CITY OF SAVANNAH

HISTORIC PRESERVATION COMMISSION

REQUEST FOR CERTIFICATE OF APPROPRIATENESS

MPC File No.: 26-002743-COA

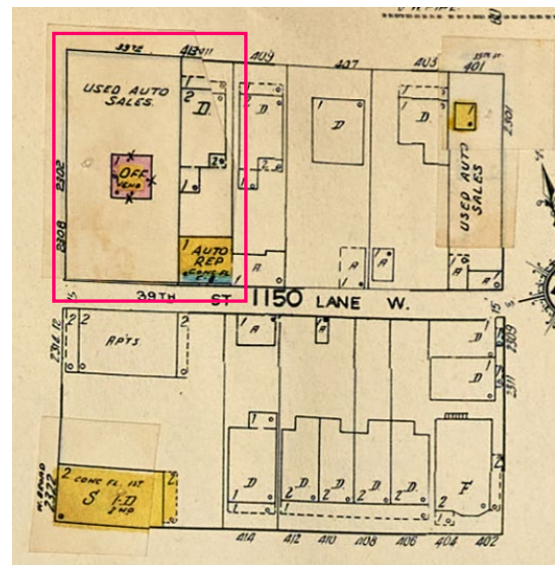
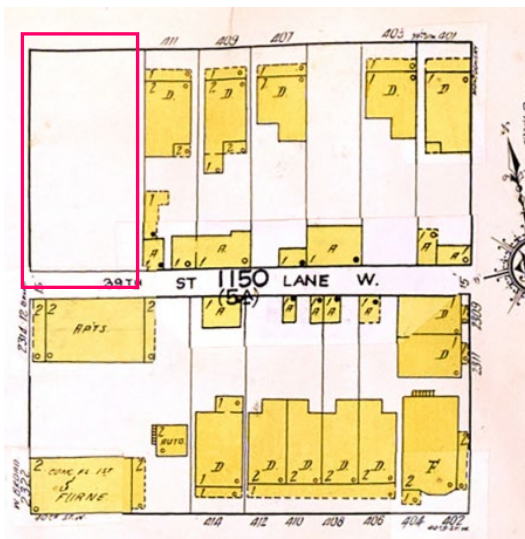
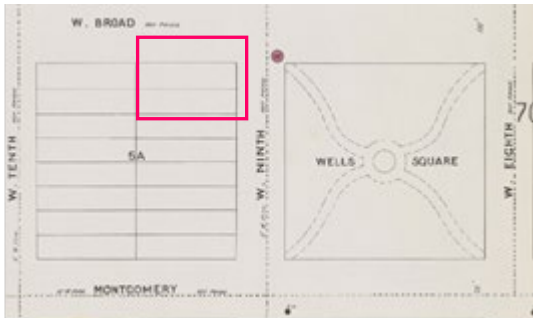
Currently there is one large lot with two non-contributing structures built in 1951. The former auto shop business is no longer operating, and the buildings are sitting vacant. If the demolition is approved, this will allow for the lot to be split into three separate lots that would be intended to each contain one duplex and one ADU. The current configuration of the lot is shown in the image.
